Vincotech – PCN – No 30-2021

SUBJECT OF CHANGE:	Module Pinout
PRODUCTS AFFECTED:	10-EZ124PA032ME-LQ17F18T; 10-EZ124PA032ME-LQ17F18T-/3/
REASON OF CHANGE:	Pin position change

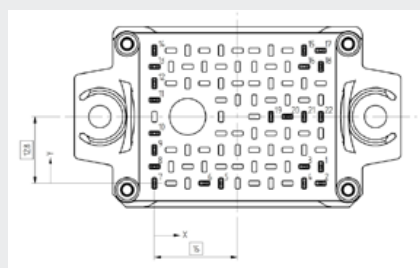
Function of pin nr 3 & 4 & 15 & 16 has been swapped

CURRENT

Pin Nr 15 -> Function G2
Pin Nr 16 -> Function S2
Pin Nr 3 -> Function S4
Pin Nr 4 -> Function G4

NEW

Pin Nr 15 -> Function S2
Pin Nr 16 -> Function G2
Pin Nr 3 -> Function G4
Pin Nr 4 -> Function S4
